Project	IEEE 802.16 Broadband Wireless Access Working Group <http://ieee802.org/16>	
Title	AES-CCM Encryption and Authentication Mode for 802.16	
Date Submitted	2004-01-10	
Source(s)	David Johnston Intel Corp 2111 NE 25 th Avenue Hillsboro, OR 97124-5961	Voice: 503 264 3855 Fax: mailto:dj.johnston@intel.com
Re:	802.16e	
Abstract	This document describes changes to the 802.16 specification, for incorporation into the 802.16e amendment. These changes introduce a new encryption algorithm, authentication algorithm and key encryption algorithm based on AES operating in CCM mode. This new mode is incorporated into the extensible cipher selector mechanism that exists in the base specification.	
Purpose	These changes are to be incorporated into 802.16e in order to enhance the available cryptographic strength of the link cipher to 128 bits and to introduce data origin authentication and data integrity protection.

AES-CCM Encryption and Authentication Mode for 802.16

Figure XXX. Initial CCM block B₄

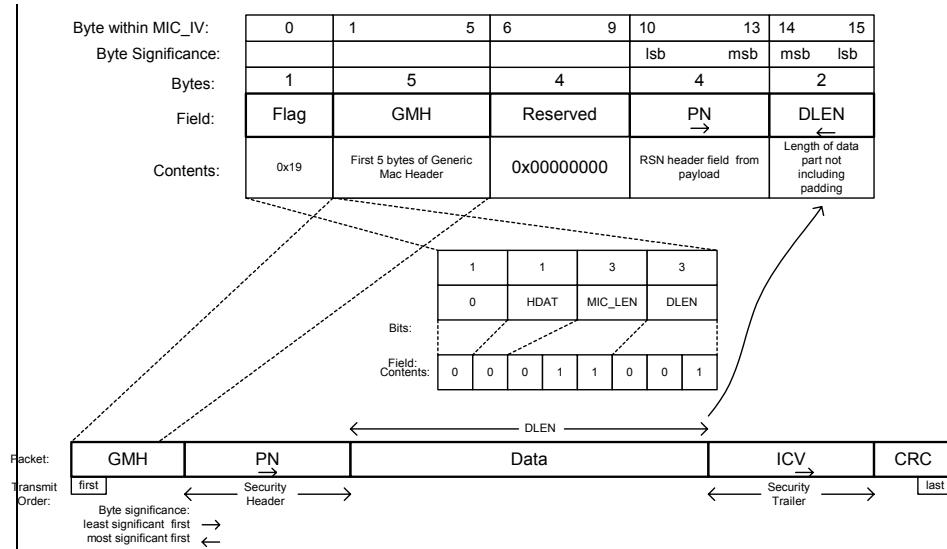
The nonce shall be 13 bytes long. Bytes 1 through 5 shall be set to the first five bytes of the GMH (thus excluding the HCS). Bytes 6 through 9 are reserved and shall be set to 0x00000000. Bytes 10 through 13 shall be set to the value of the PN. Byte 10 shall take the LSB and byte 13 shall take the MSB.

Consistent with the CCM specification, the initial block B_0 is formatted as shown in figure xxx.

Note the big endian ordering of the DLEN value is opposite that of the normal little endian representation. This is to remain compliant with the letter of the NIST CCM specification.

The 6th byte of the GMH is not included in the nonce since it is redundant.

Figure xxx. Construction of A_i

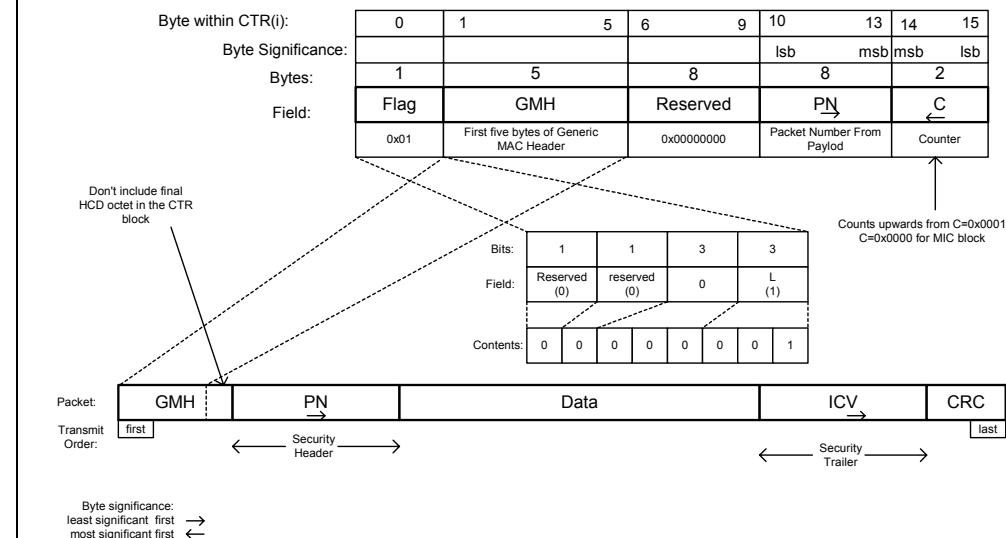
Consistent with the NIST CCM specification the counter blocks A_i are formatted as shown in figure xxx.
